**ADDENDUM NUMBER:** TWO (2)

**DATE:** February 17, 2026

**PROJECT:** LONE OAK COMMUNITY CENTER

**DESIGNER:** BRETT HARBISON, ARCHITECT  
MONTGOMERY COUNTY ENGINEERING

**G0.2A**

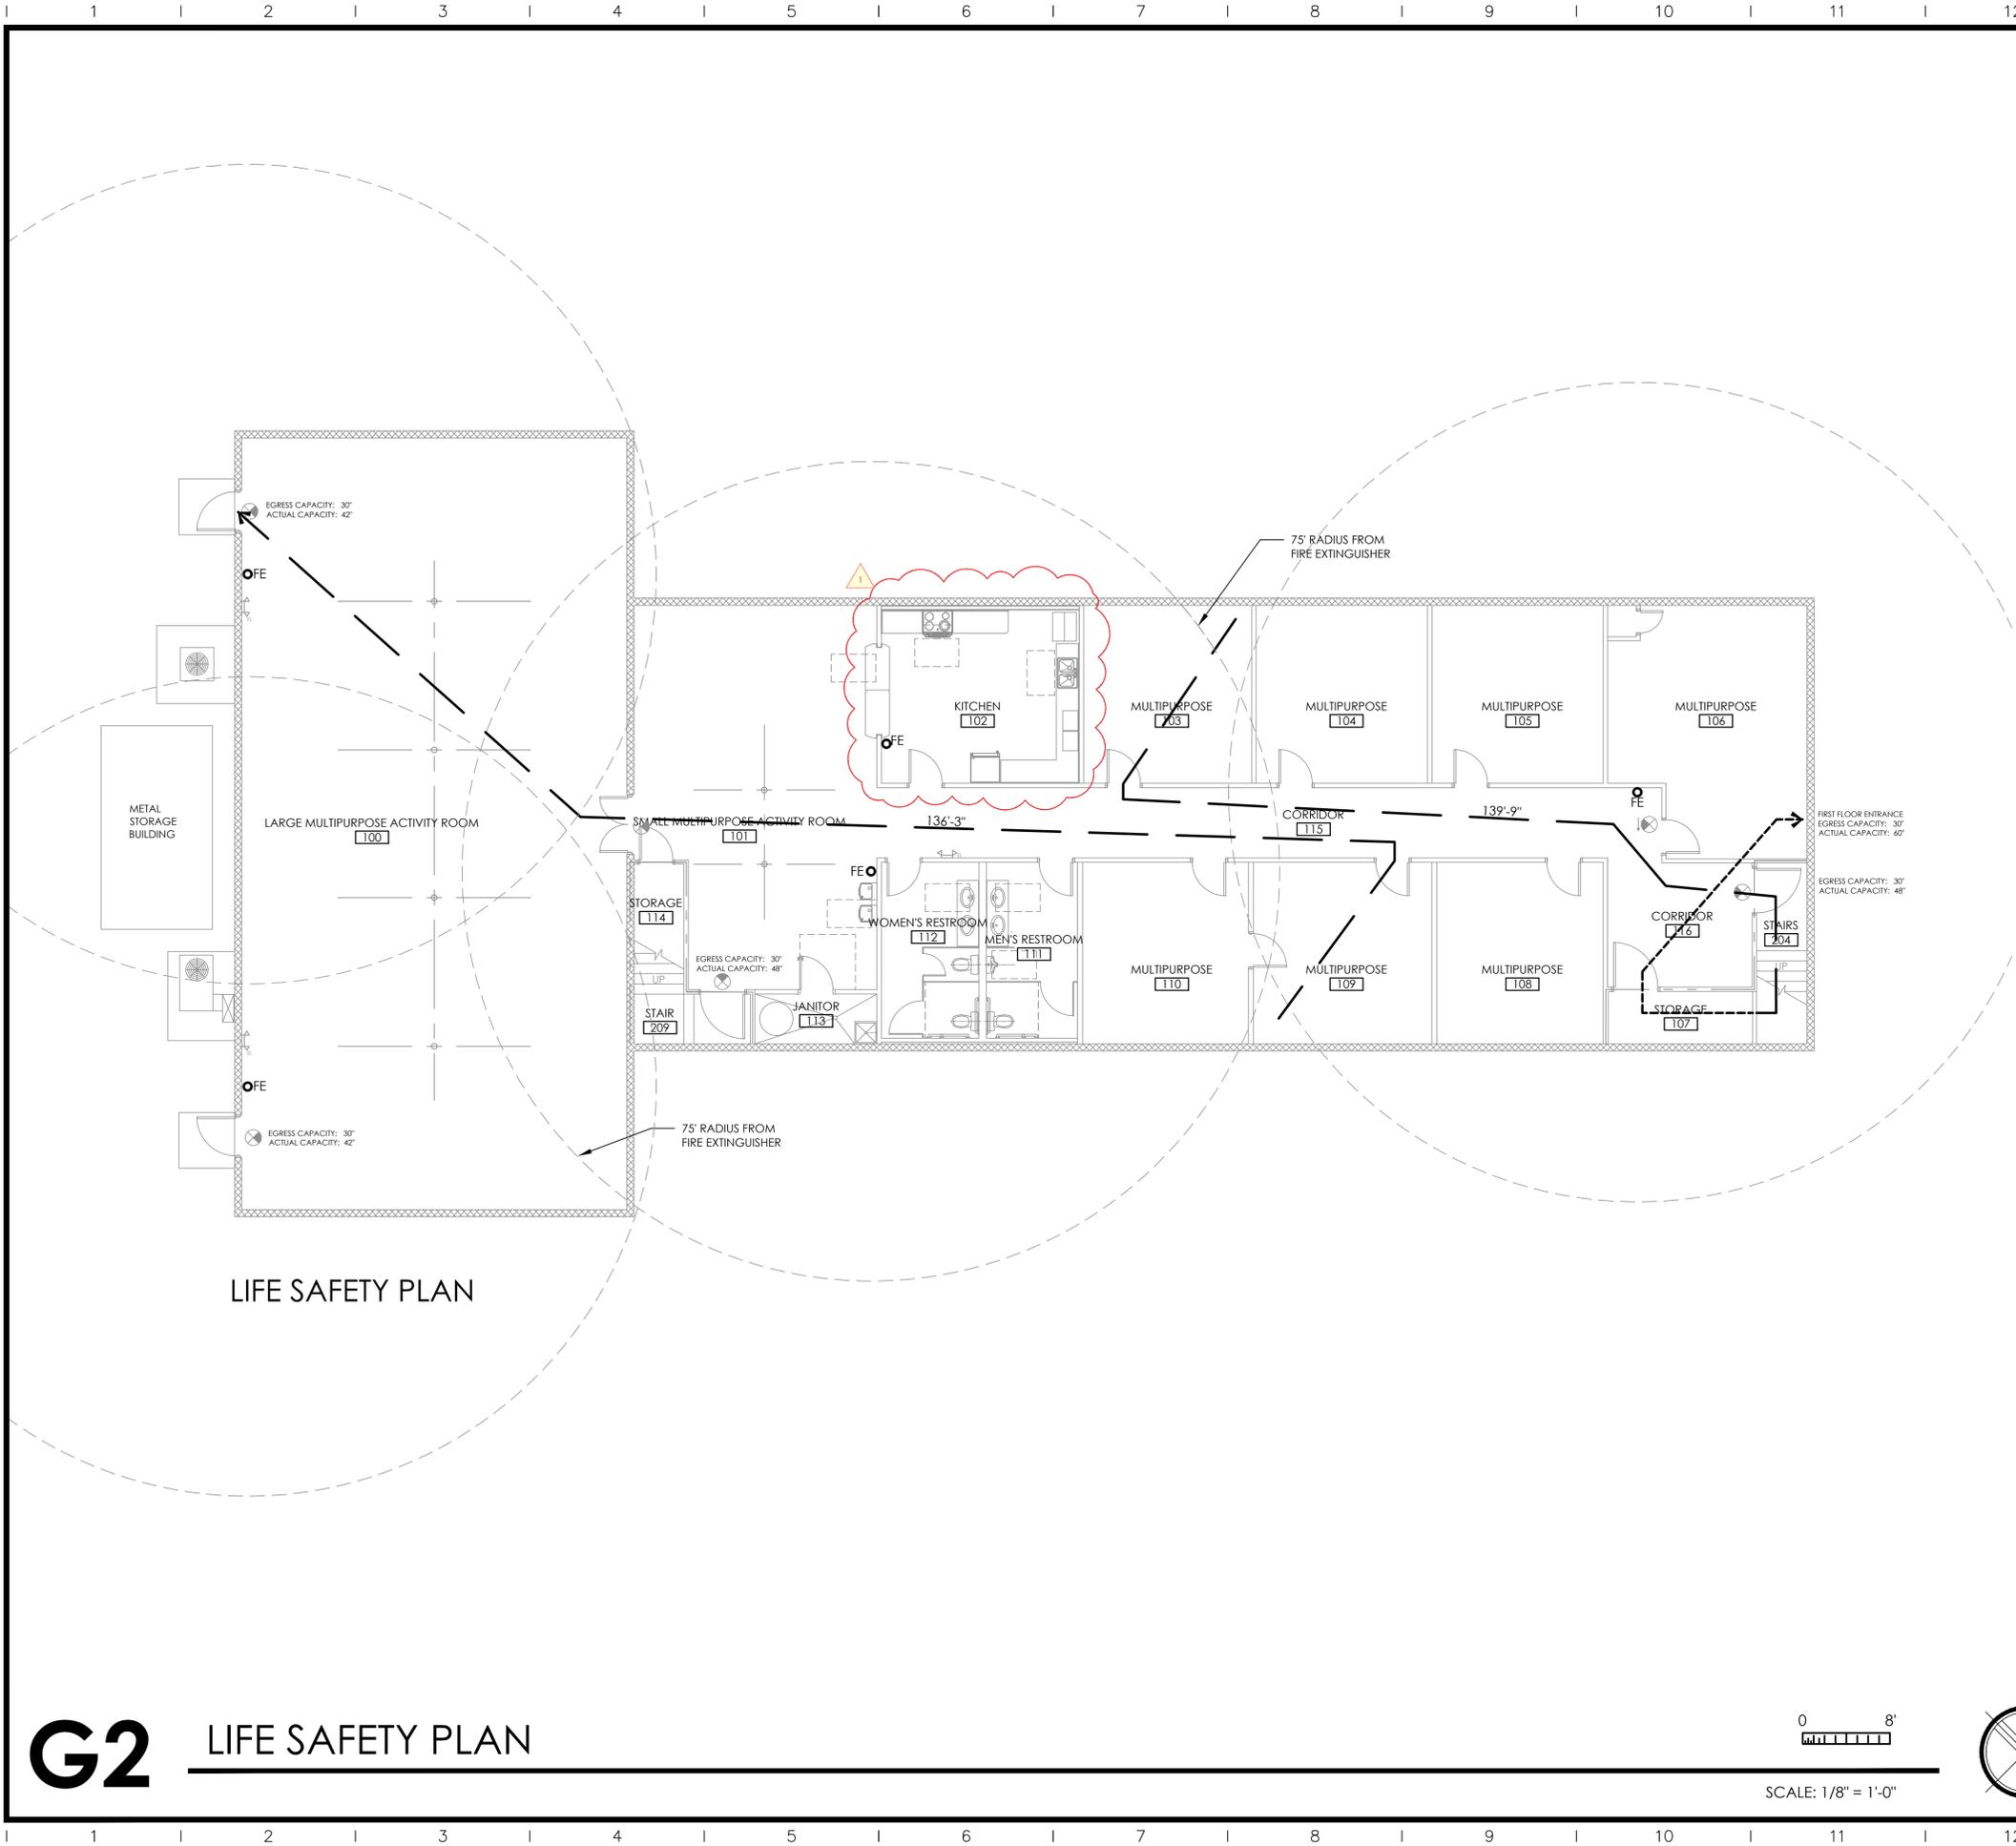
Updated kitchen layout to show correct plan.  
Corrected radius circles for fire extinguishers

C1.0

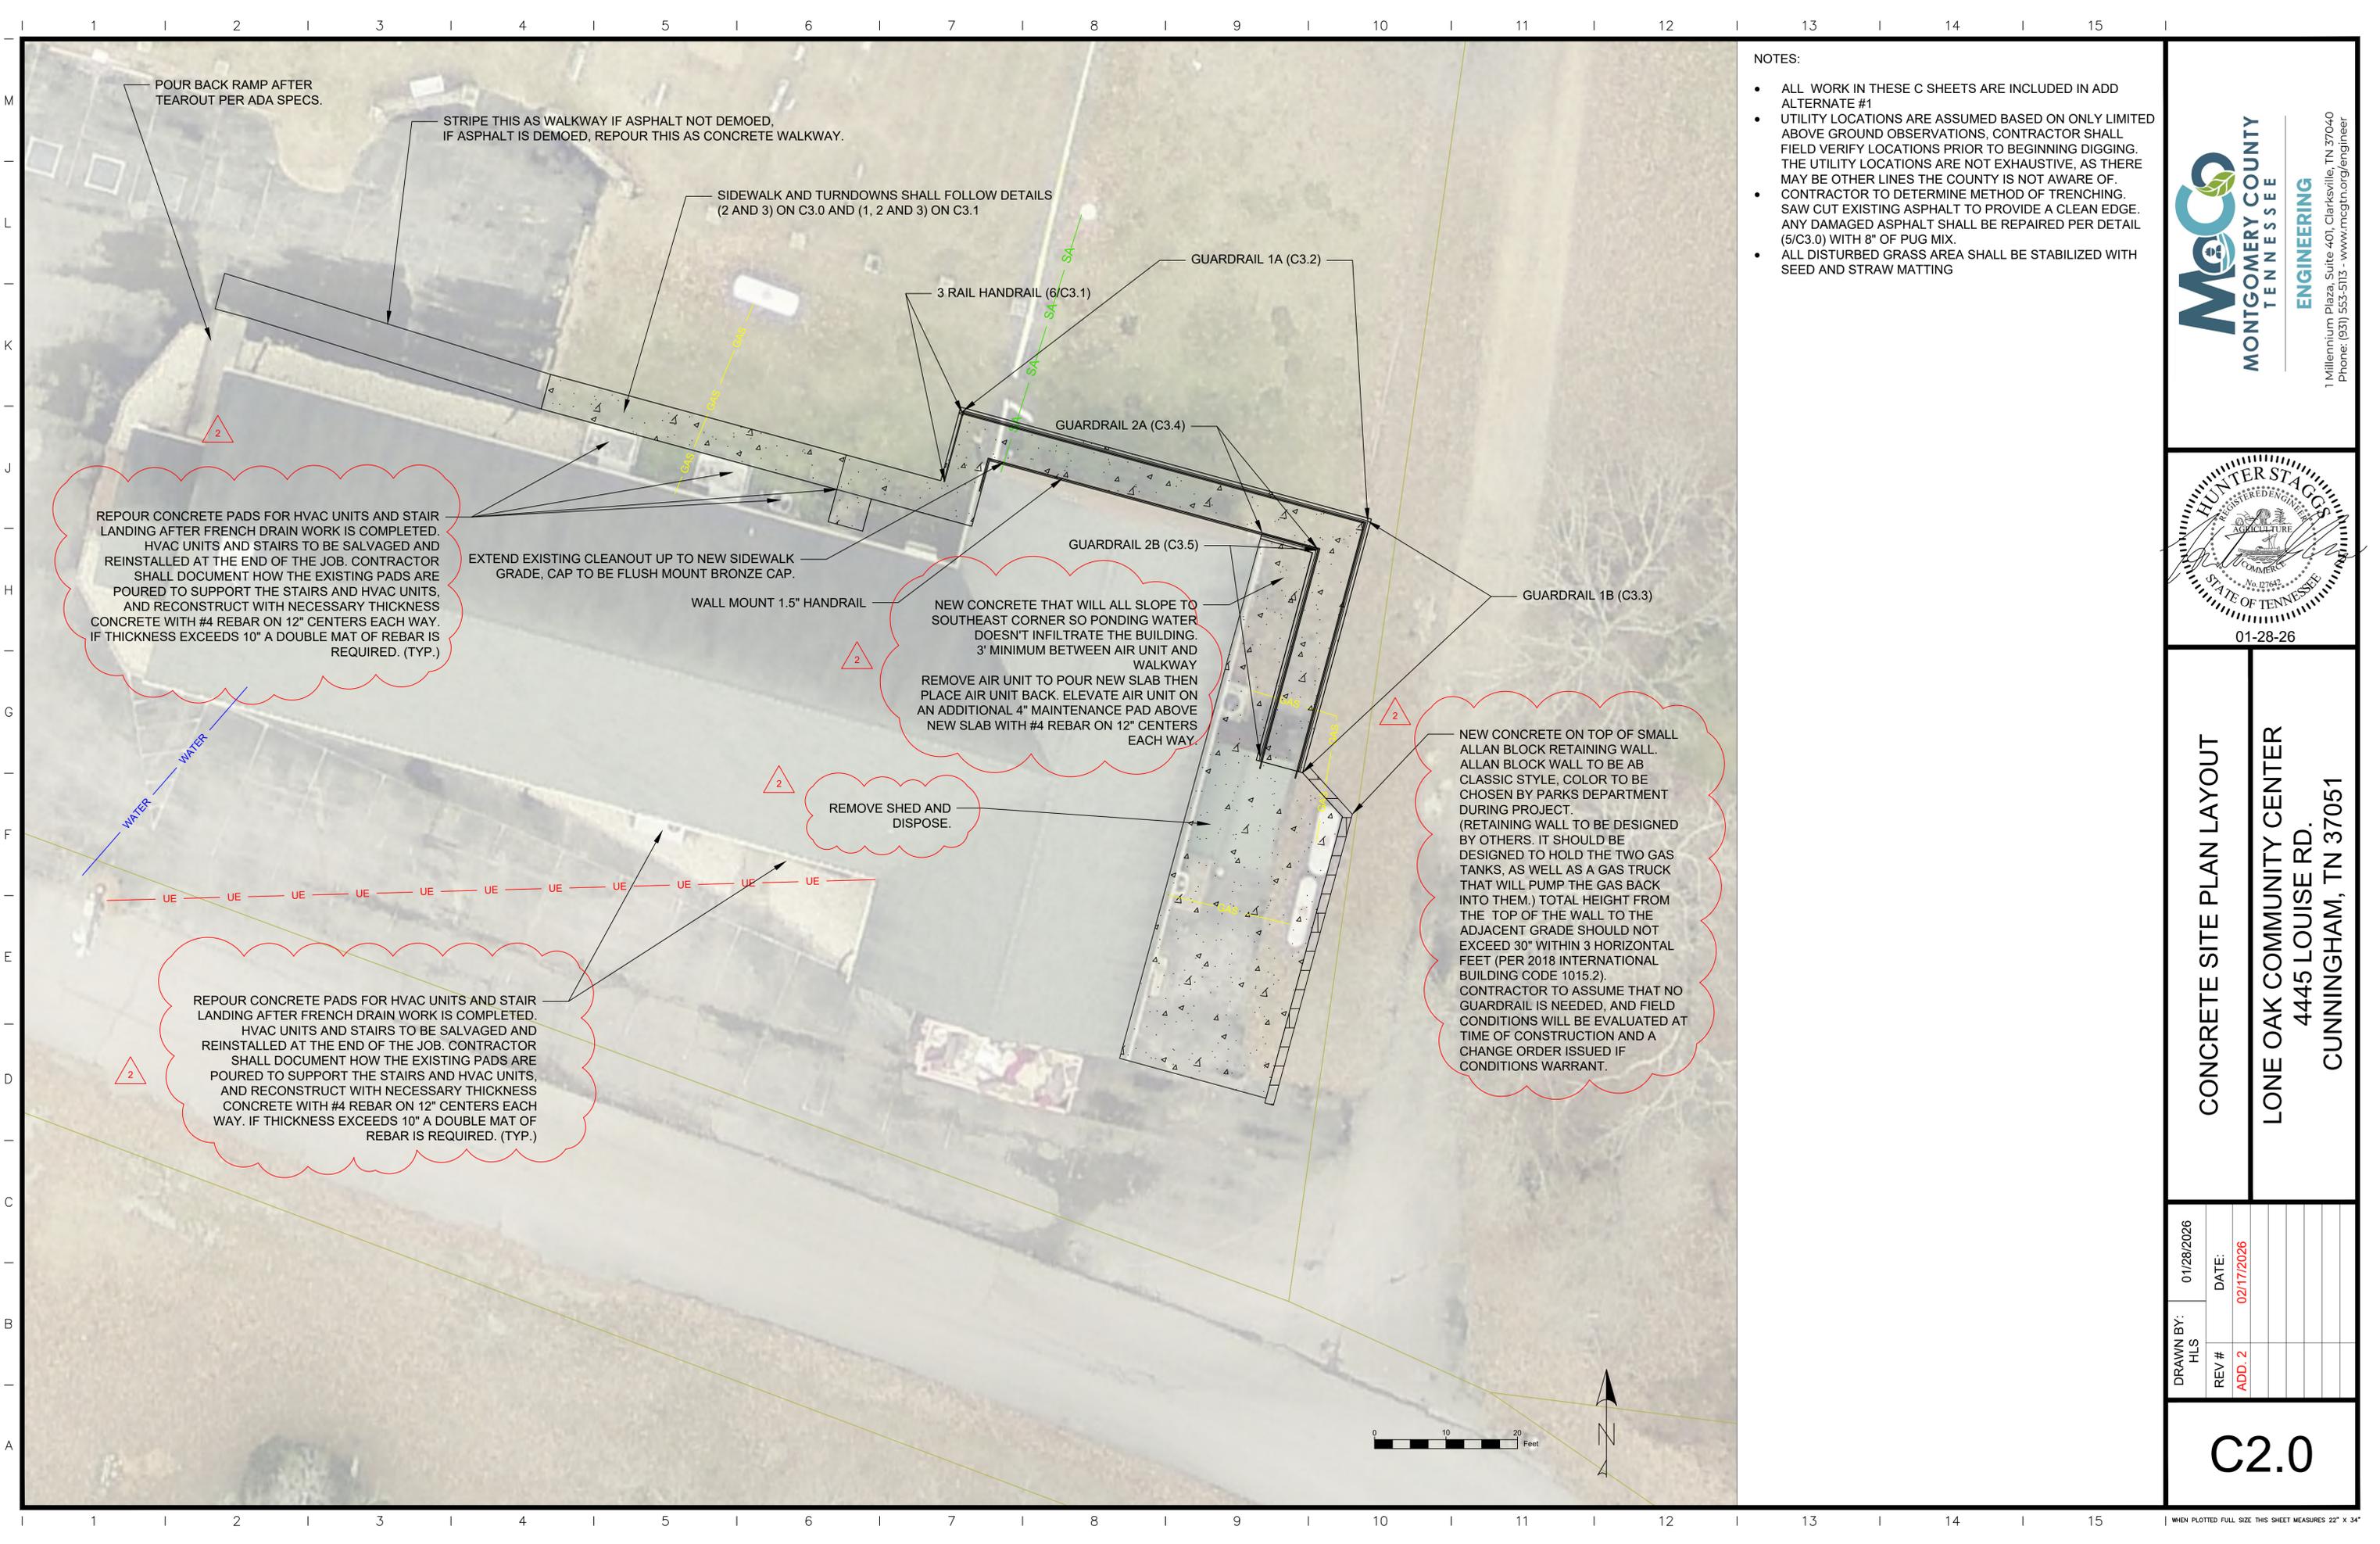
Clarification, downspout lines do not tie into the French drain, there are three separate lines. The foundation French drain that daylights on the far East, the downspout collector that gets 3 northwest side of the building downspouts as shown, and one that gets corner downspout near the existing fence. Downspout collector for corner downspout has been downsized to 4".

Clarification for areas to receive waterproofing.

Clarification for approximate location of water line

Clarification to salvage and reuse existing landscaping stone at the end of the project.

Clarification for HVAC unit verification of operability before removal, removal, concrete pad replacement, and HVAC unit reinstallation.

Clarification on removal of chain link fence, and three rail vinyl fence.

**CONCRETE SITE PLAN LAYOUT**

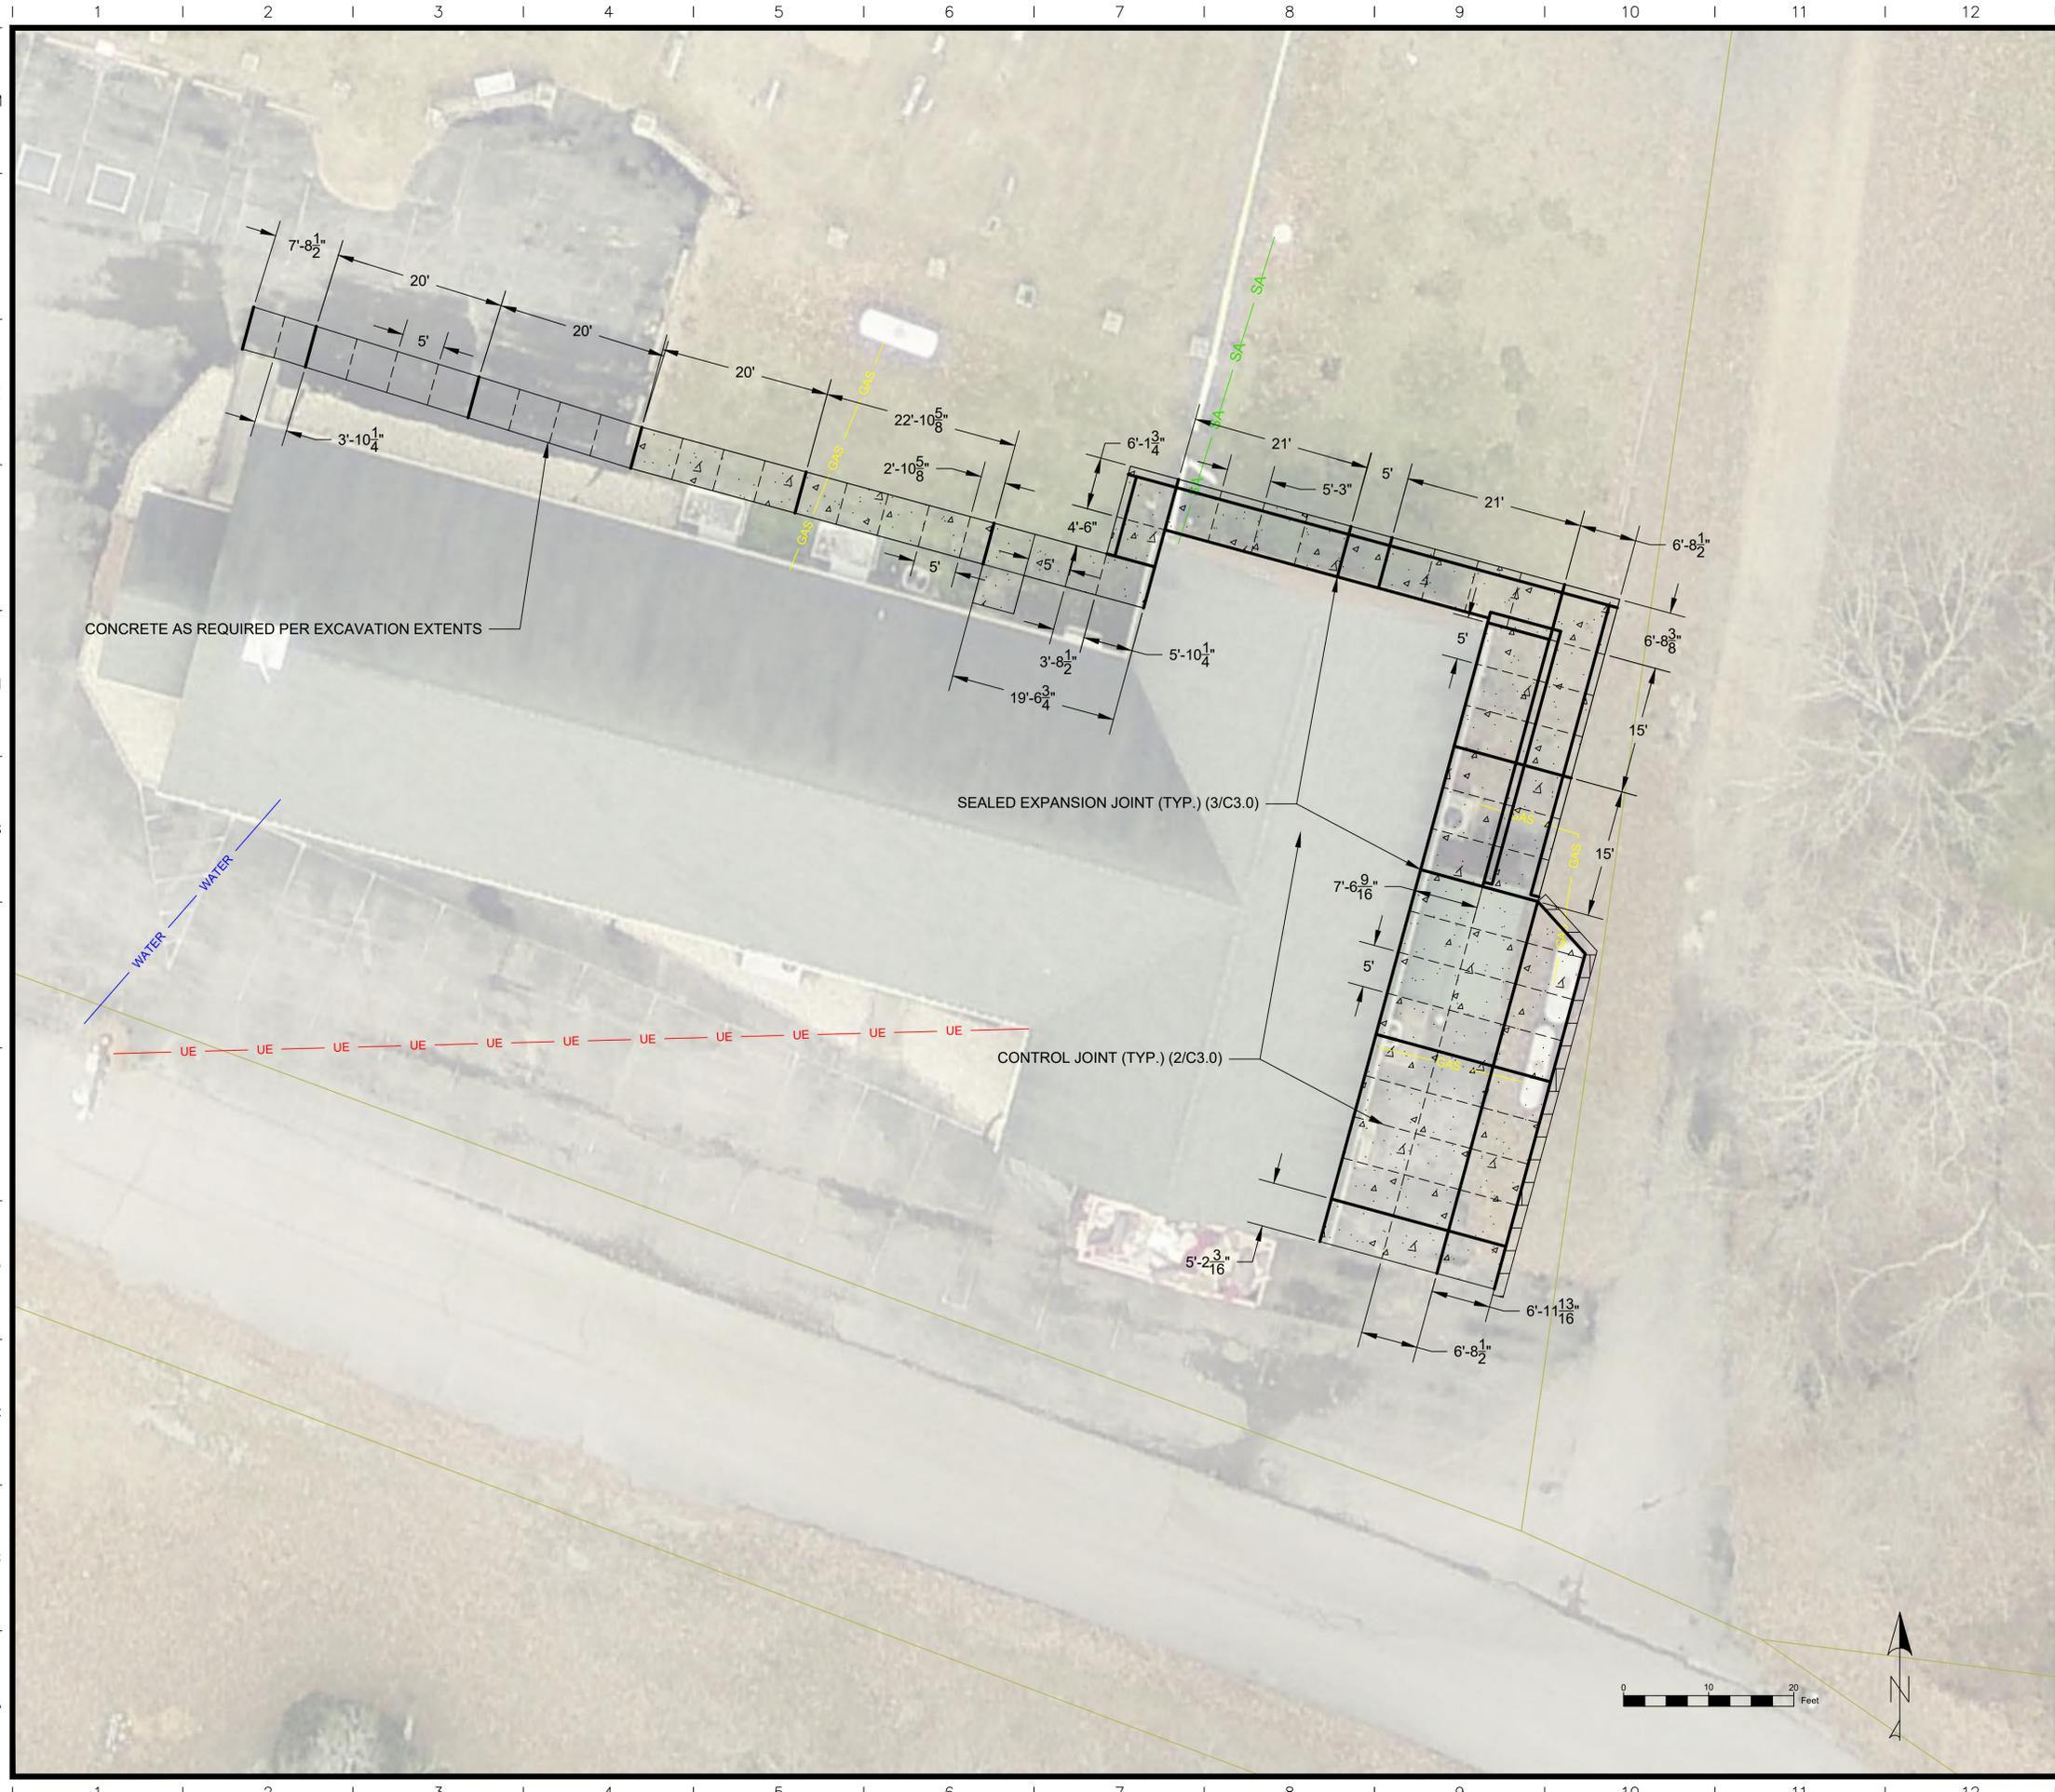
Clarification of type of Allan Block Retaining wall style, and the guardrail on top of the wall being taken out of the initial bid and if field conditions necessitate it, we will add it via change order.

Clarification of removal and disposal of existing shed.

Clarification on specifics of HVAC pads
